SERVICE BULLETIN

EQUIPMENT: C-5000

BULLETIN NUMBER: WSB C-5000-3

Changes will improve CTCSS and DCS receives tone operation.

Figure 2. C-5000 CTCSS/DCS Tone Module 300-018390 Installation Drawing

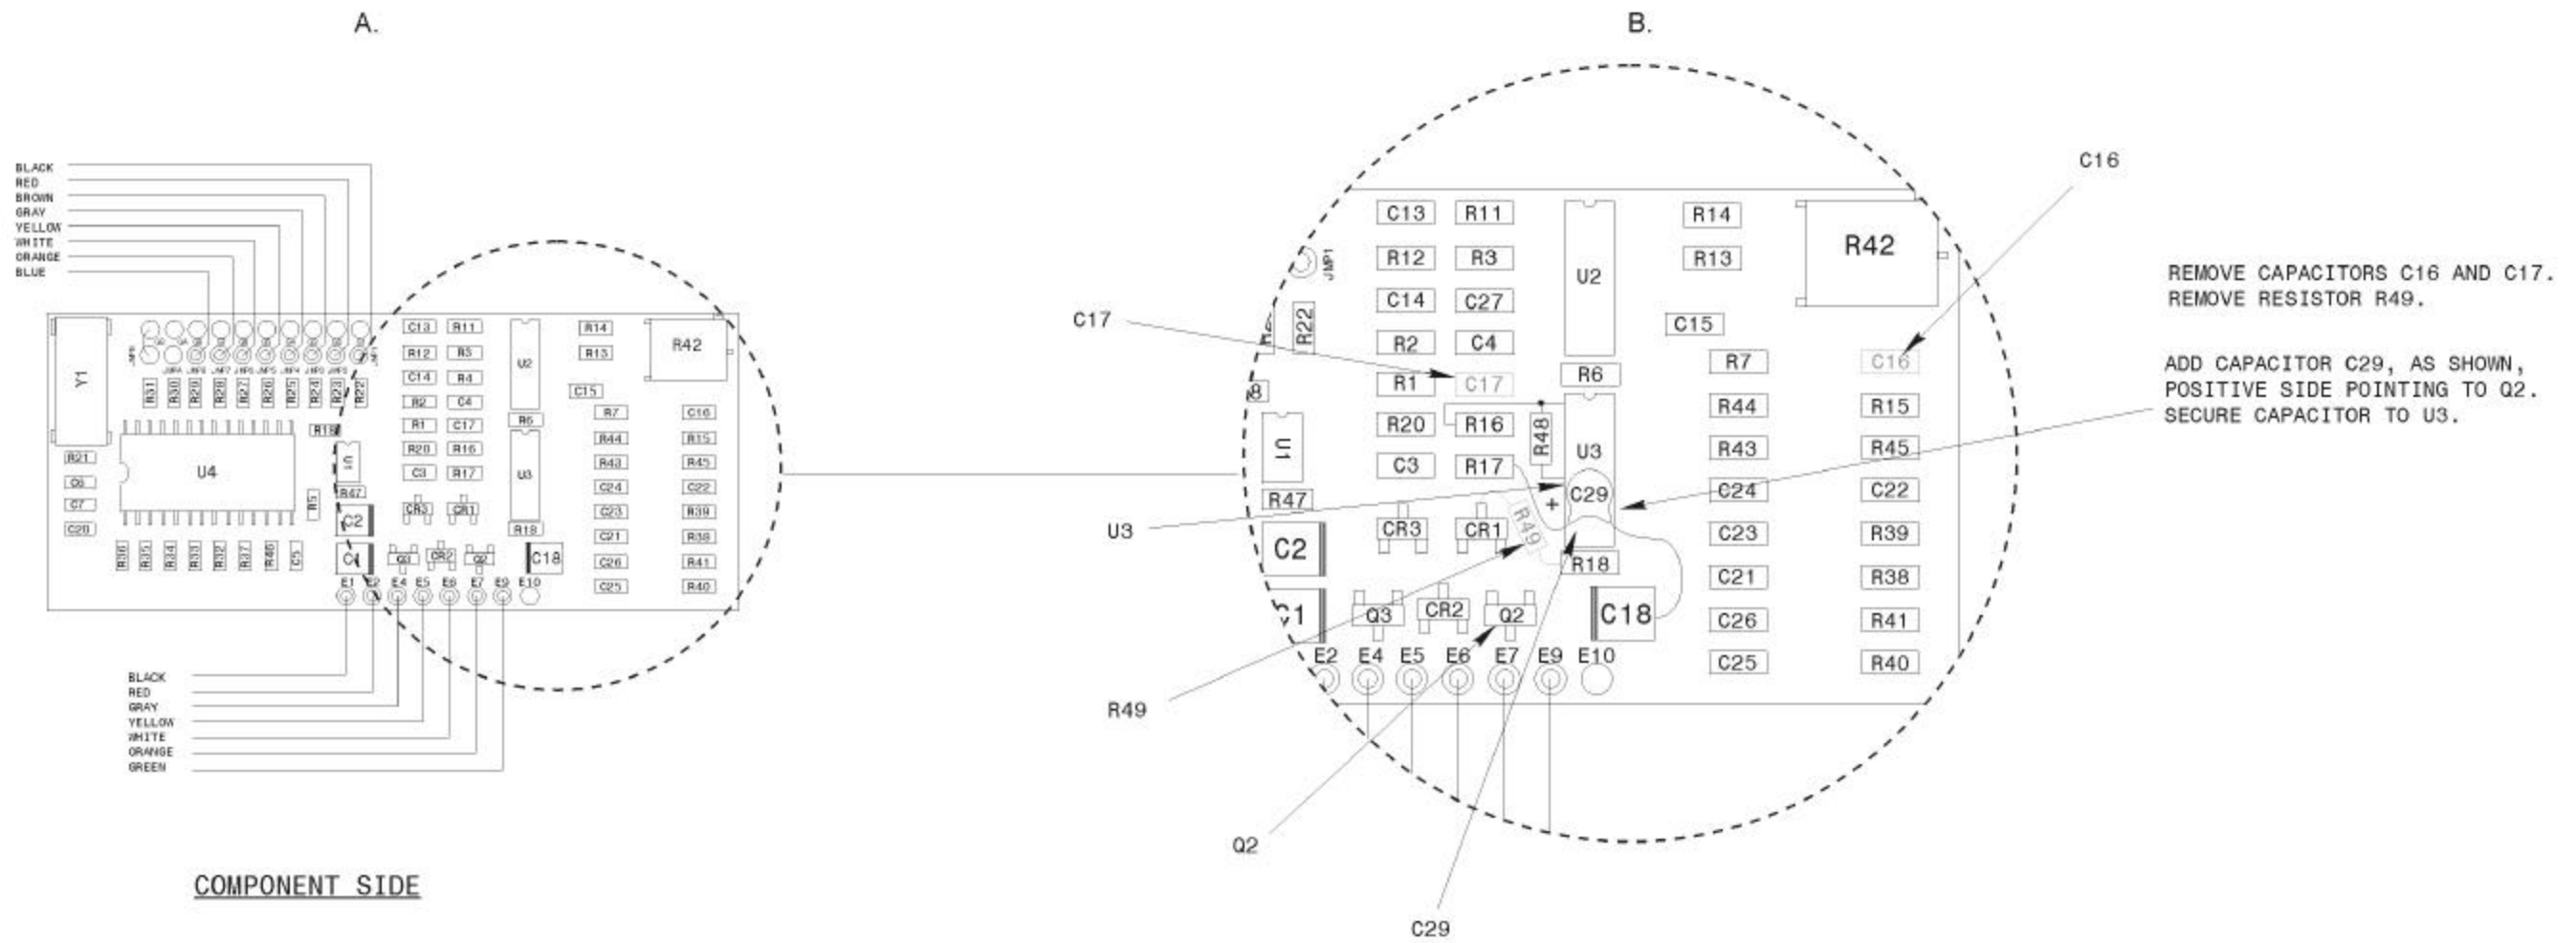
This modification consists of removing a jumper, two capacitors, and a resistor, and adding a capacitor.

2. Remove the parallel interface board that has the CTCSS/DCS Tone Module installed. Parallel boards can be identified by the connector with three rows of pins (serial board connectors have two rows of pins).
3. Remove capacitors C16 and C17 and resistor R49 as shown in Figure 2B. Refer to Figure 3.
4. Add capacitor C29, P/N 096-01082-0046 (Item 1), positive side pointing toward Q2, as shown in Figure 2B. Refer to Figure 3.
5. Secure Item 2 to U3 using Tak Pak adhesive (Item 2) as shown in Figure 2B.
